Able Marine Energy Park

Material Change 2

Applicant's Response to

the MMO's D3

Source Figure 12 of Appendix UES9.3

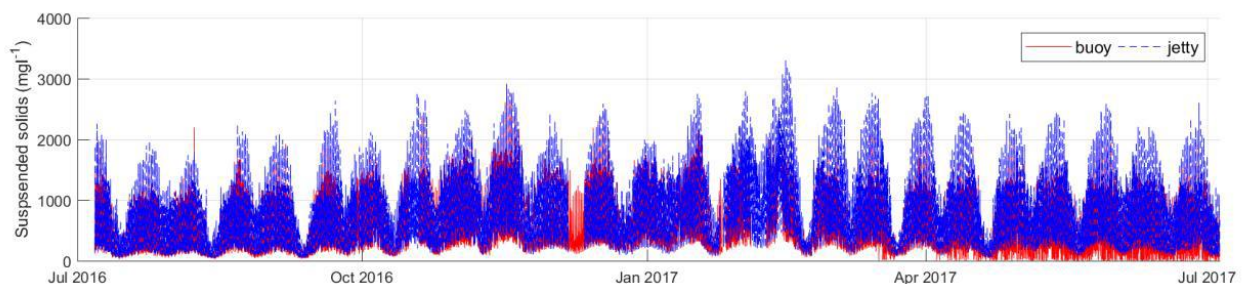
3.1 The MMO note that Sections 6.2.1 (early phase) and 6.3.1 (late phase) present data on depth-averaged suspended sediment concentration (SSC) increases, which indicate (absolute) increases over background of up to 50mg/l. The general conclusion is that the absolute increases are low in an estuary context. However, Section 4 (background SSC) lists peak SSC (at various estuary locations around the site) which the MMO consider would be more valuable presented as background values (while minimum values would be indicative of the potential worst case instantaneous change). It can be assumed that the works will occur at 'off-peak' times (i.e., dredging is not likely to occur in excessive weather/flow states associated with peak SSC) so the relative increase over background is not well represented. While the MMO appreciate that the peak value shows that very high SSC is not unusual in the location, comparison with the mean would make a stronger point with respect to the significance of the chronic effect.

The MMO are suggesting that the peak SSC described may occur at times of excessive weather or river flow states and that dredging may not occur at these times. This is not necessarily the case for an estuarine environment. The factors most influencing SSC in the vicinity of the AMEP site will likely be tidal range, tidal surge; river discharge/rainfall and local wind wave action. It is not certain that any of these conditions, except perhaps exceedingly high winds, would affect the dredging activity (and as acknowledged, dredging vessels would be very unlikely to operate in such conditions in any case). The figure below (Figure 12 from UES Appendix UES9.3) shows the time measurements of suspended sediment concentration at two locations in proximity to the AMEP site measured over a year. The strong correlation with the spring-neap tidal cycle can clearly be seen, with elevated concentrations (typically peaking at 2,000 to 3,000 mg/l) at the time of spring tides and reduced concentrations at the time of neap tides (typically peaking at 200 to 500 mg/l).

Given the low levels of suspended sediment increase above background levels predicted to occur for the simulated dredging activity and the time varying nature of natural suspended sediment concentrations over the course of a spring-neap cycle it is not appropriate, in the view of HR Wallingford, to consider the plume concentrations, for this particular dredging activity, against the

mean measured concentrations. This approach was not requested by the MMO for other simulation results presented.
